**SECOND RESPONSE TO REQUEST FOR ADDITIONAL INFORMATION  
PERMIT TO OPERATE COMPOSTING FACILITY  
PERMIT TO CONSTRUCT LEACHATE TREATMENT FACILITY  
PERMIT TO OPERATE RESOURCE RECOVERY FACILITY  
WASTE TIRE GENERAL PERMIT  
AND  
PERMIT TO MAINTAIN CLOSED CLASS I SANITARY LANDFILL  
PREPARED FOR**

Mr. Kim B. Ford, P.E.  
Solid Waste Section  
Division of Waste Management  
Florida Department of Environmental Regulation  
4520 Oak Fair Boulevard  
Tampa, Florida 33610-7347

**RE: SUMTER COUNTY SOLID WASTE FACILITIES**

**PERMIT NO.:**      **S060-211179 - SOLID WASTE COMPOSTING**  
**WT60-211205 - WASTE TIRE STORAGE**  
**S060-211182 - M.R.F.**  
**SF60-211255 - LONG-TERM CARE**  
**SC60-211181 - LEACHATE TREATMENT**

GROUNDWATER ELEVATIONS - APR 7, 1992

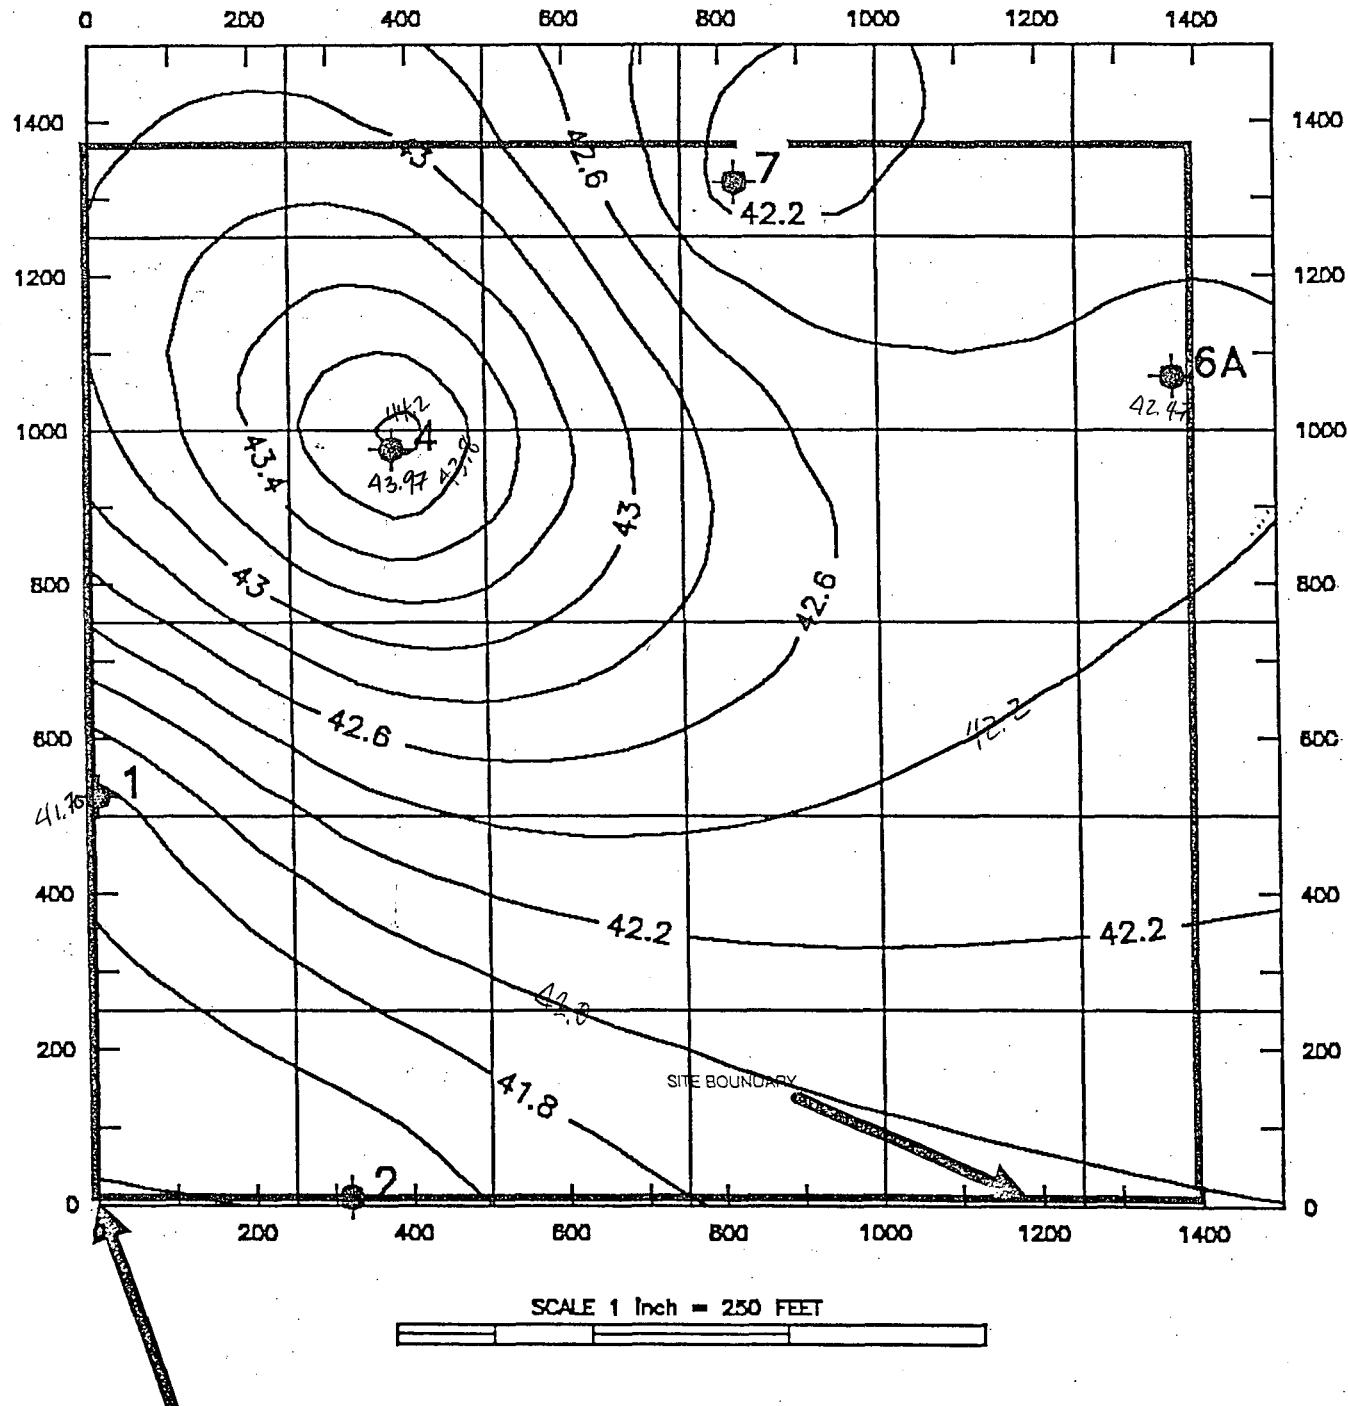
4. The elevations given are N.G.V.D. The monitoring interval is quarterly.
5. The Groundwater elevation contour maps in Appendix F need some explanation. The asterisks seem to denote monitor well locations, but do not coincide with monitor well locations on the map provided in Appendix D. The data by each asterisk does not appear to correspond with the data provided in tabular form. The contours do not reflect the numerical values printed by each asterisk.

5. The bottom left-hand corner of the Groundwater Elevation Maps presented in our response dated May 29, 1992 corresponds to the southwest corner of the present facility. The asterisks did denote the location of the monitoring wells and did generally coincide with the locations shown on the map enclosed in Appendix D of the response dated May 29, 1992. The numbers should have been the well numbers. This has been corrected and revised Groundwater Elevation Maps are enclosed in Appendix C.

**SHEET 1 of 4**

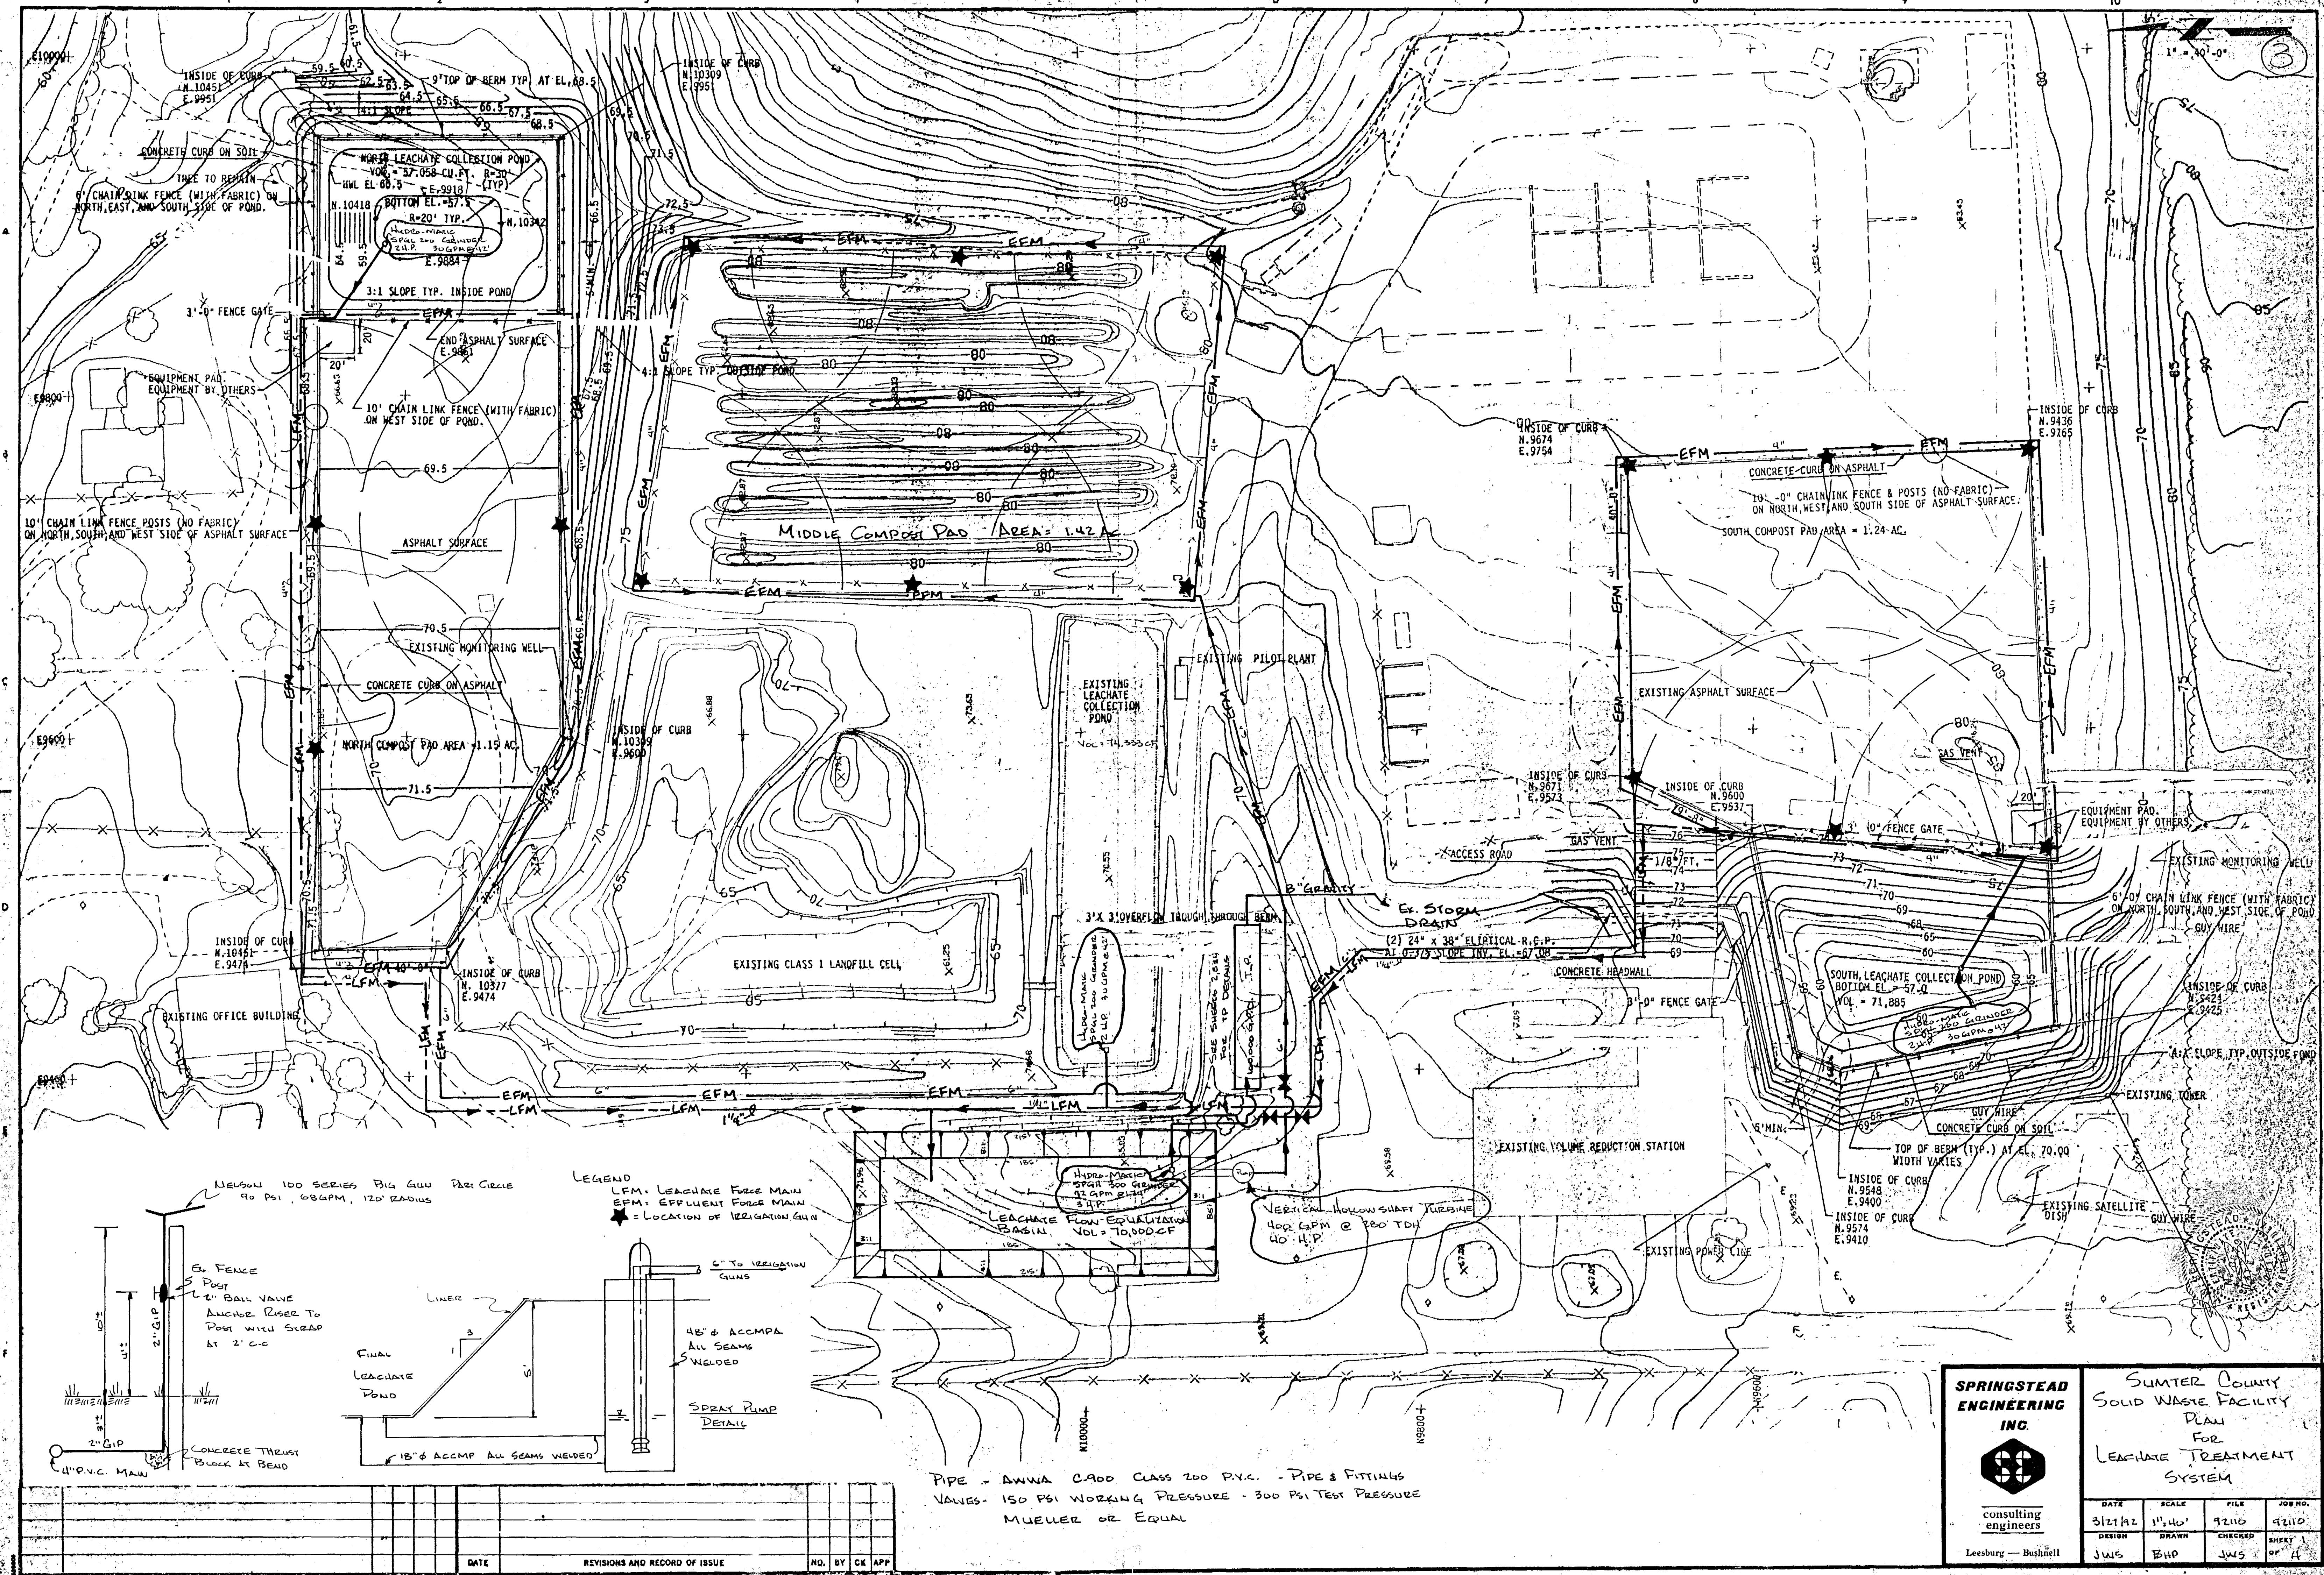
8. Provide water balance calculations to show the volume of leachate that can be evaporated by recirculation. These calculations shall include consideration of:
  1. how leachate will be recirculated;
  2. detailed plans for layout and operation
  3. capacity of the windrows to absorb leachate;
  4. hours of operation;
  5. extended period of rainfall and;
  6. conditions for no recirculation.

- (8.1.8.2)      Conceptual plan as presented in Sheet 1 of 4, dated 3-27-92, shows the piping layout and details of the leachate treatment system. Sheet 1 of 4 is enclosed in Appendix F.
